REVIEW COMMENTS

FILE #SPR-96-106

TITLE HEADING: Unitel Addition

LOCATION: 610 25 Road

Grading and Drainage Plan
Unitley
610 25 Road
Grand Junction, CO: 81505

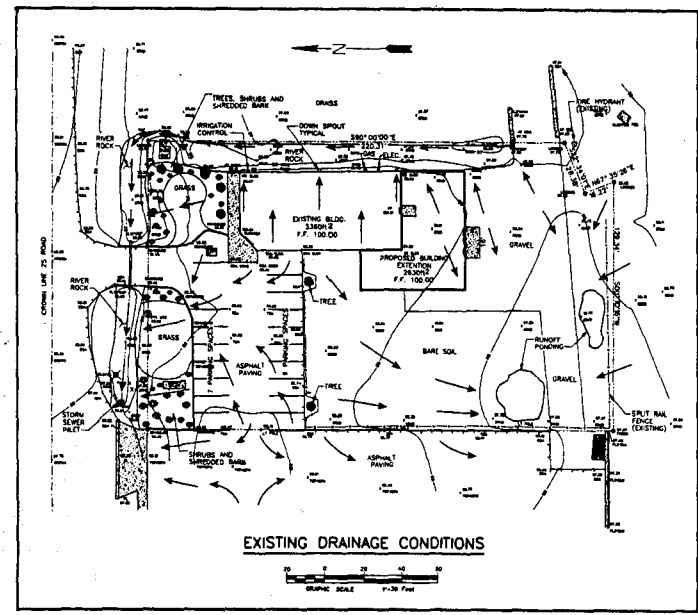
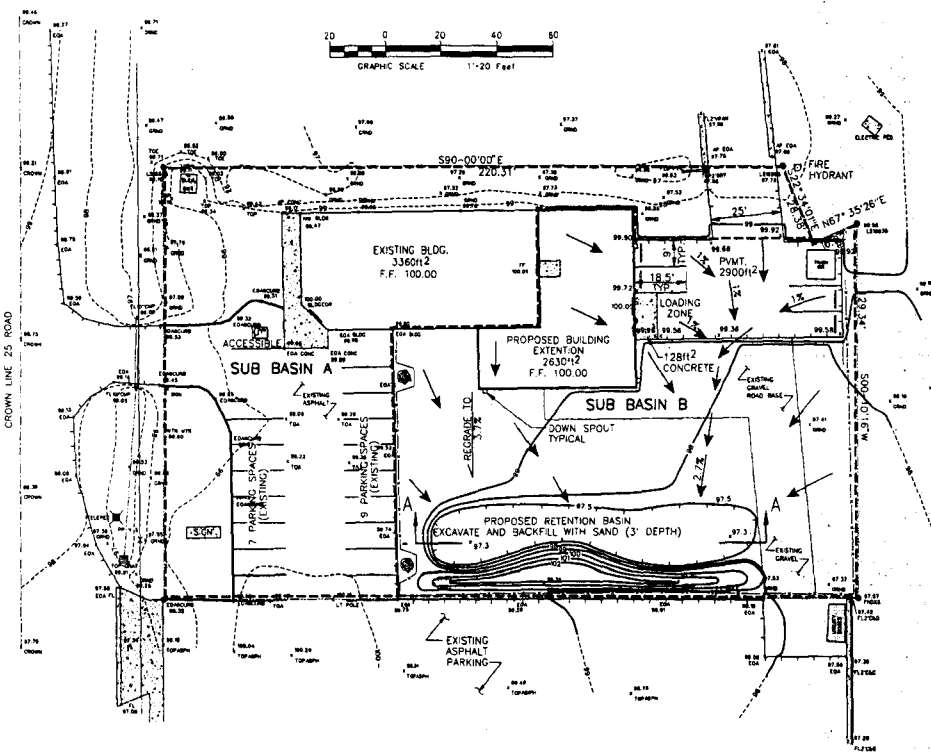
1. The site is wholly within the Drainage District. The District operates and maintains the 25 Road tile which flows into the Buthorn Drain. The 25 Road tile is incorrectly called out as a storm sewer on the grading and drainage plan. The tile is near the east right-of-way line of 25 Road. The addition should not encroach over the tile if built as shown.
2. The on-site retention is a good idea.

Site and Landscape Plan
Unitel
610 25 Road
Grand Junction, CO. 81505

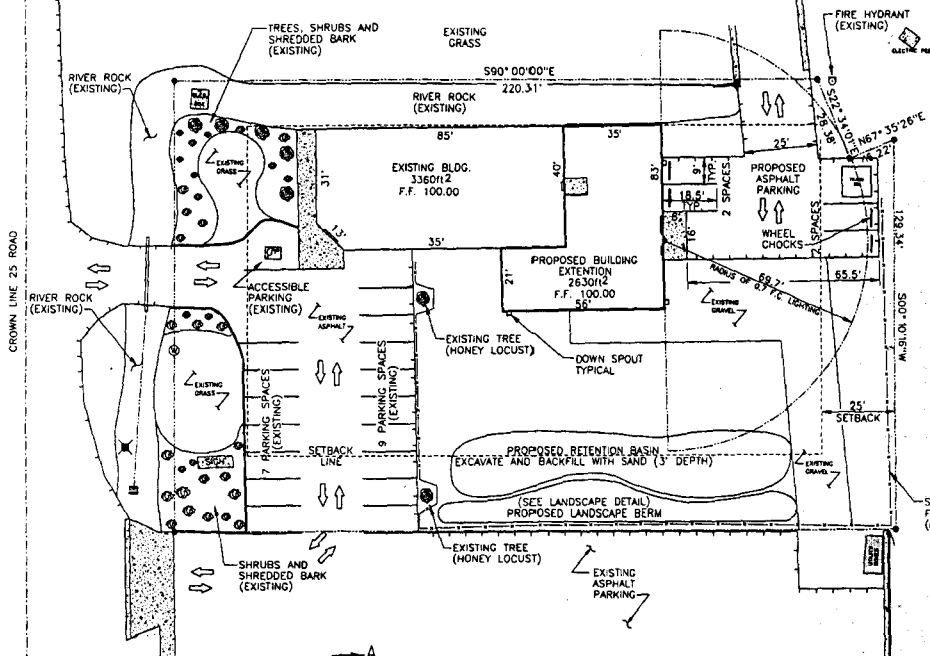
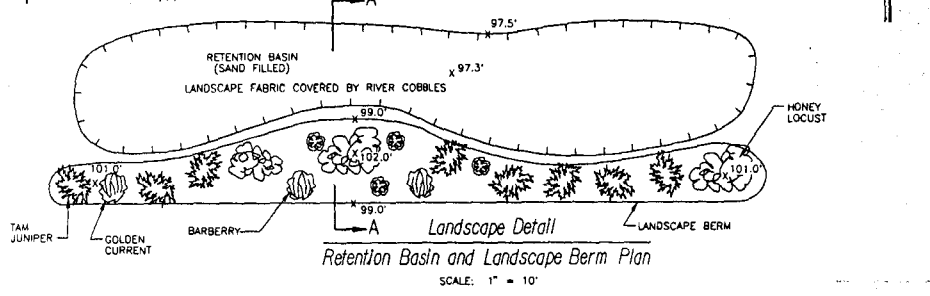
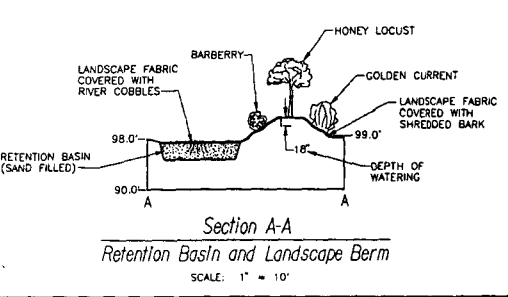
3. A site visit indicated there is an existing light pole in the parking lot circulation area. It appears this is an impediment to circulation and should be relocated.
4. The site plan shows access and circulation through adjacent properties. Are there existing ingress/egress/access agreements in place? If not, these need to be secured with adjacent property owners.

1. North arrow is incorrect on plans.
2. What is dimension of front property line (not shown)?

1. Access to both the front and rear parking lots appears to be through adjacent properties. Provide copies of access easements/agreements with adjacent property owners for both access drives.

2. Site Plan must show all area needed to show access to the existing and proposed parking area.
3. If the driveway from the south will still be used to access the new parking area, it must be paved with asphalt (including the area off-site). If the driveway is to be blocked as an access to the new parking area, there is a need for a turn-around area in order to back out of the parking space in the southeast corner of the new parking area. Also, show on plan how this drive will be blocked so the rear parking area may not be accessed from the south. *(blocked)*

4. The gravel drive into the rear parking area from the north must also be paved.
5. Number of parking spaces shown (existing + proposed = 21 spaces) is adequate for total square footage (existing + proposed).
